Comments on Green Hill Solar Farm ENO010170

## RESPONSE TO APPLICANT'S RESPONSES TO WRITTEN REPRESENTATIONS AT DEADLINE 1 : HYD-003 – LAVENDON

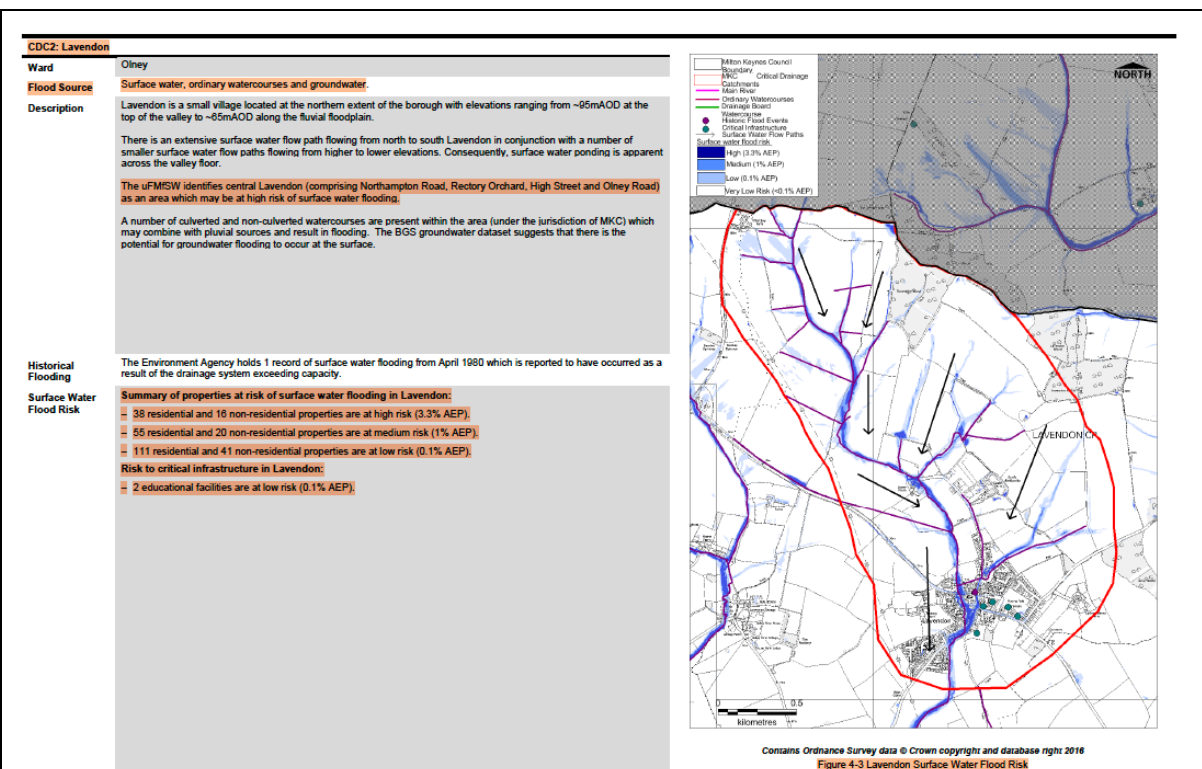
The developer's attention is drawn to the Surface Water Flood Risk comments as well as the surface water flow paths. **Three of the surface water flow paths run through sites G-9 and G-13.**

#### Location F

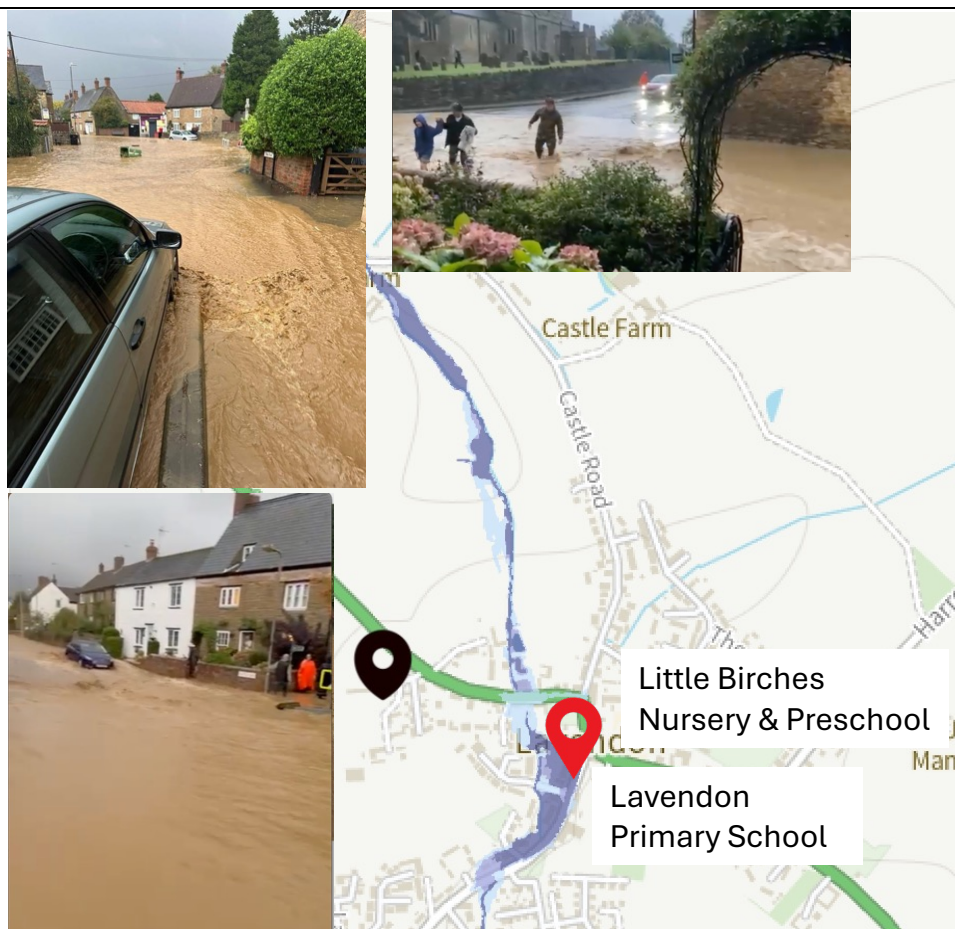
*This picture shows a timber post upon which has been marked, in white the height of the storm water flood passing under at 11.00pm on 22<sup>nd</sup> September 2024. This measures 1.65m from the limestone channel bed. Below is the 700mm line indicating the maximum height modelled at 3.3% AEP. Below that are the small reduction markers of levels if earth bunding is introduced. The 1.6m depth is equivalent to > 0.1% AEP. The drainage channel flows 1km down to Lavendon and passes under the A428 via a concrete culvert (Location E). This could not cope with the force of the flood water and over spilled into adjoining properties and the village.*

*The developer, in accordance the documents referenced as part of their own design and FRA, should read the notes from the Environment Agency (EA) and Lead Local Flood Authorities (LLFAs) and Flood Estimation Handbook (FEH) and include these as Historic Flood Events to recalibrate their hydraulic models.*

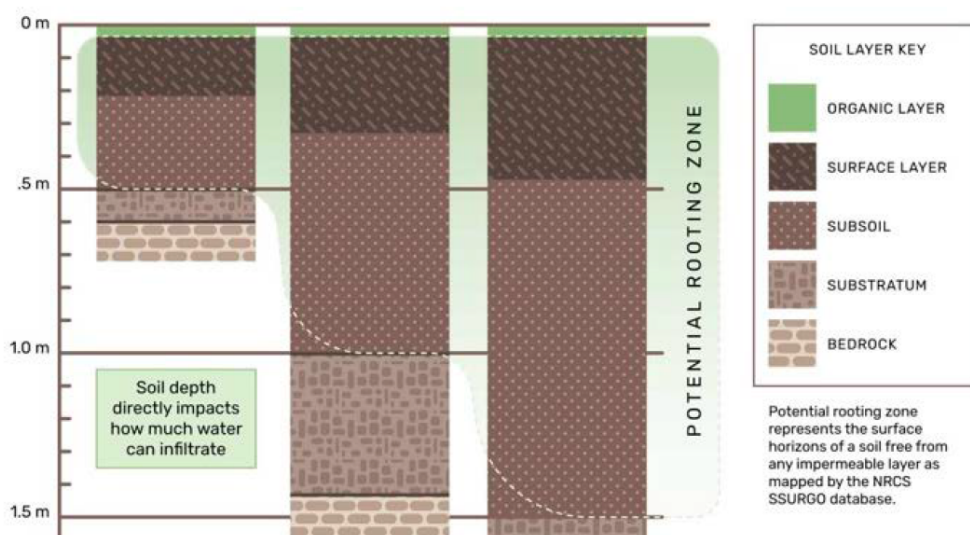
1. **Compaction**—managing soil compaction and bulk density across the site. **Runoff increases on average by 98% with compacted vs. loose soil in full sun areas**

*Please could the developer comment on the findings of this research, particularly the findings concerning soil depth.*

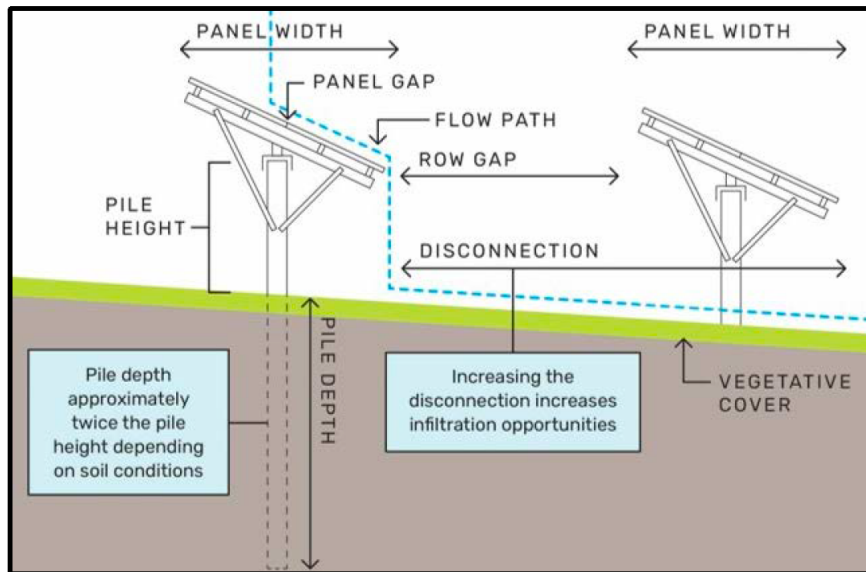
2. **Soil depth**—including soil depth (rooting depth) in stormwater modeling and design. **Runoff increases on average by 78% as soil depth decreases from 150 cm to 50 cm.**

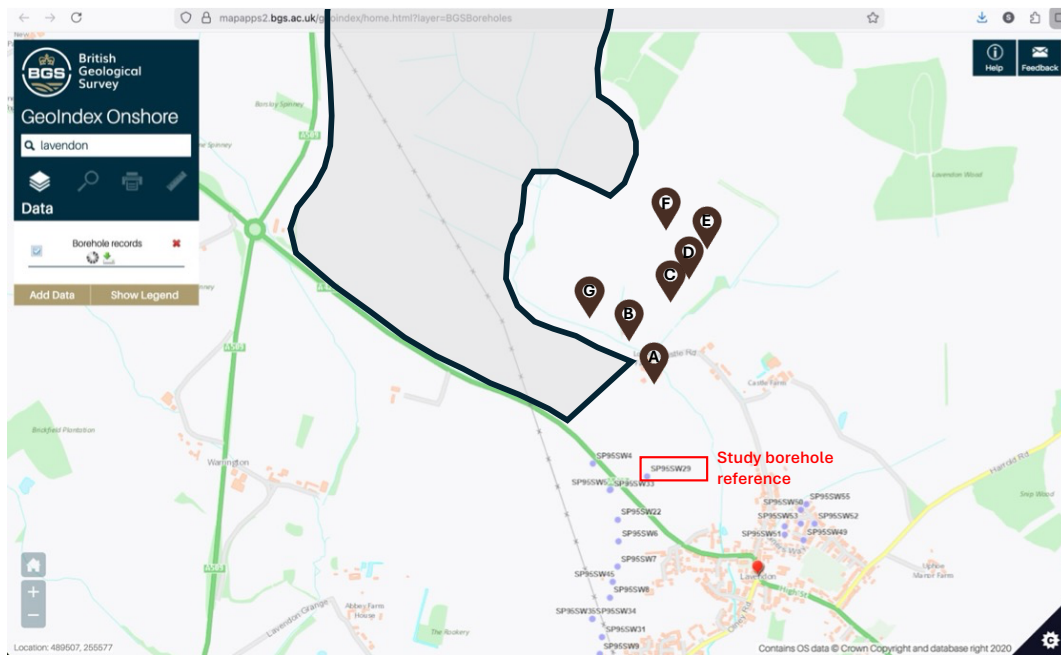
*In Clause 1.6.2 it is stated that the geological mapping is available at a scale of 1:50,000 and as such may not be accurate on a Site-specific basis.*

*The respondents took the time to physically visit the site and dig coordinated trial holes at more relevant points to the development. Trial holes were excavated until hard limestone was found. The plan/location of these trial holes compared to the quoted borehole reference is:*
